IPS Working Group  
INTERNET-DRAFT  
<draft-ietf-ips-fcencap-wglc-00.txt>  
(Expires September, 2002)

## FC Frame Encapsulation WG Last Call

This ips (IP Storage) working group draft contains all the working group last call comments received regarding:

draft-ietf-ips-fcencapsulation-06.txt

Comment 77 Technical

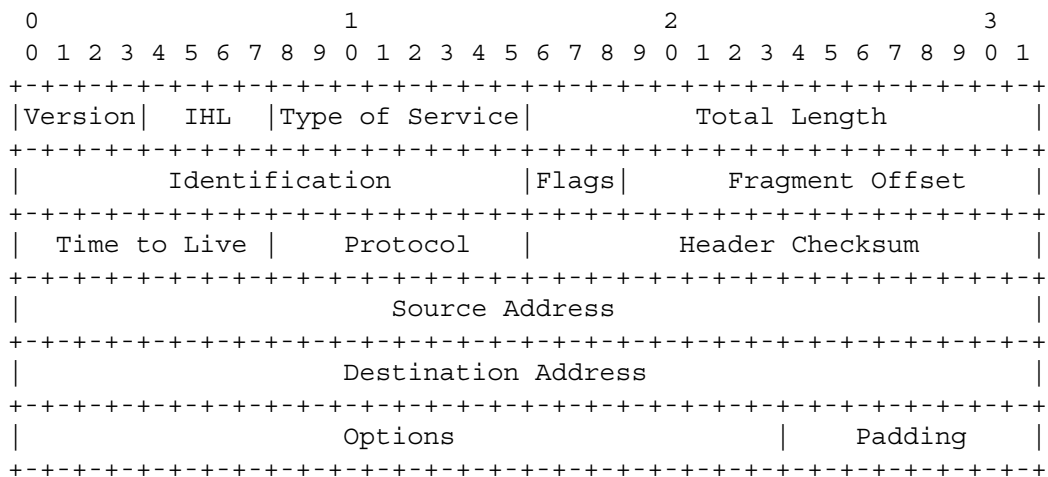
The draft fails to conform to the following requirement stated in <http://www.ietf.org/ID-nits.html>.

- 1) Add the following paragraph immediately following the Table Of Contents: "Warning to Readers Familiar With Fibre Channel: Both Fibre Channel and IETF standards use the same byte transmission order. However, the bit and byte numbering is different. See Appendix A for guidance."
- 2) Change figures 2, 3, and 5 to conform to the IETF bit and byte numbering;
- 3) Remove bit and byte numbers wherever they appear in the text; and
- 4) Insert Appendix A with the following text:

"Fibre Channel bit and byte numbering can be observed if the data structure heading shown in figure 6, is cut and pasted at the top of figure 2 and figure 5.

"Fibre Channel bit numbering for the Flags field can be observed if the data structure heading shown in figure 7, is cut and pasted at the top of figure 3.
